ADMINISTRATIVE AMENDMENT

PROJECT NUMBER: 1009881
 Application Number: 18 DRB-70047

LEGACY NAA APARTMENTS
 SAN PEDRO AND ALAMEDA
 Albuquerque, New Mexico

As Built - Parking Count Revised August / 19/ 2020

A1.10

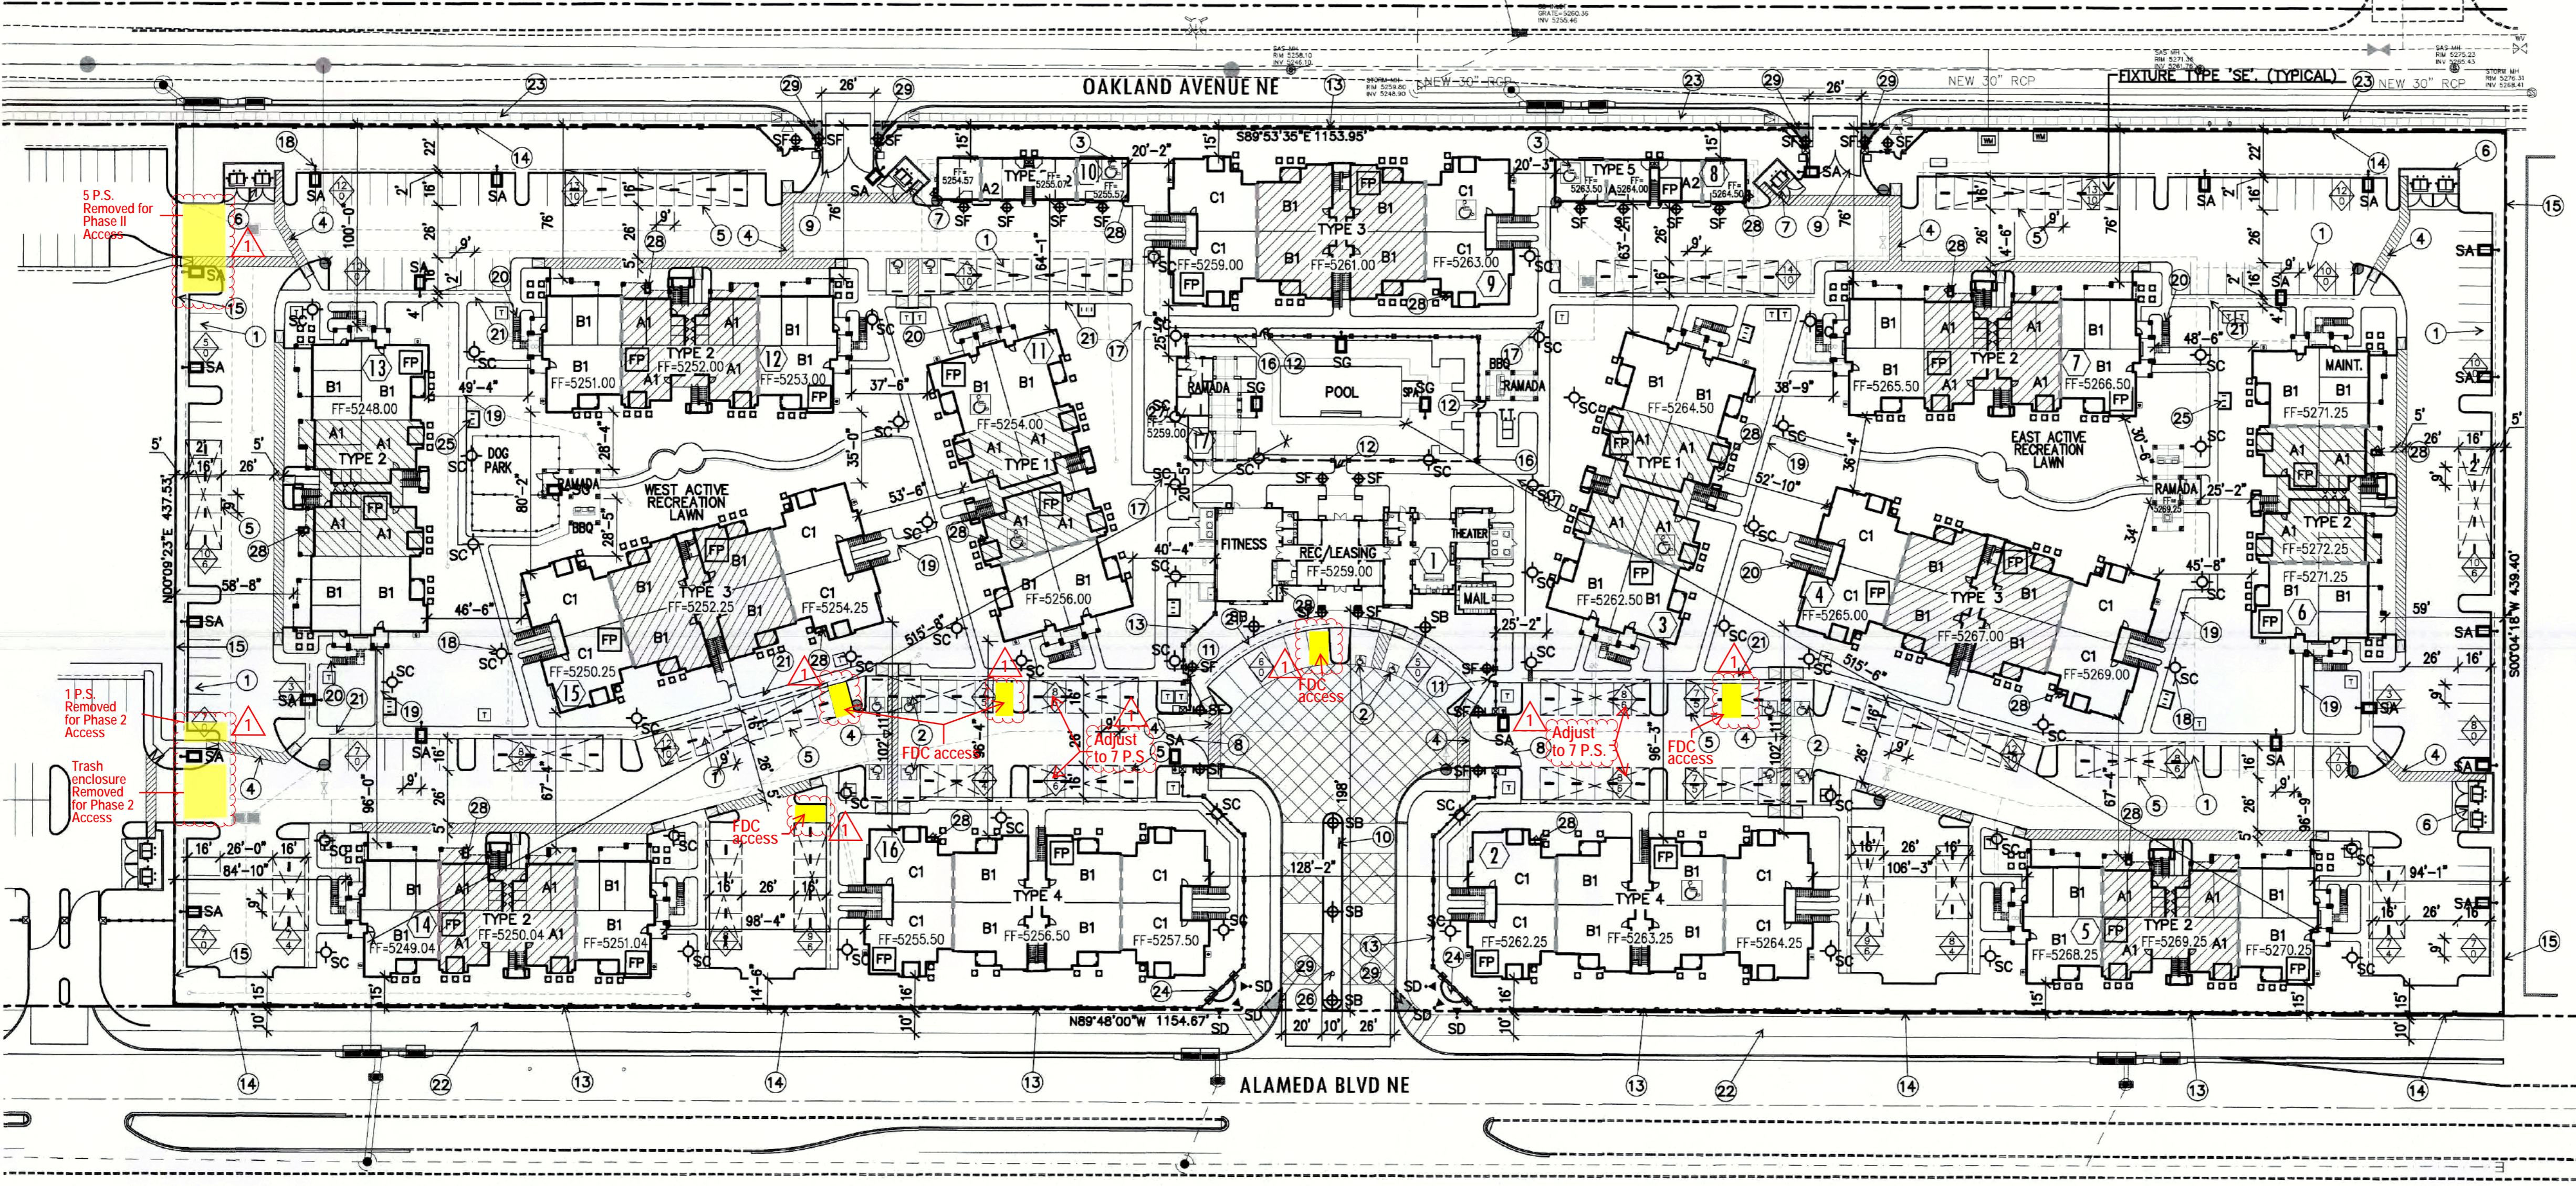
PARKING SPACE REQUIREMENTS	PARKING RATIO REQUIRED	PARKING SPACES	
			UNIT A1, A2 < 1,000 SF
UNIT B1 > 1,000 SF	104 - 2 BR / 2 BATH	2 / 2	208
UNIT C1 > 1,000 SF	40 - 3 BR / 2 BATH	2 / 2	80
Total Parking Spaces Required			420
OPEN PARKING PROVIDED		185	175
CARPORIT PARKING PROVIDED		187	156
GARAGE PARKING PROVIDED		75	
Total Parking Provided		447	406
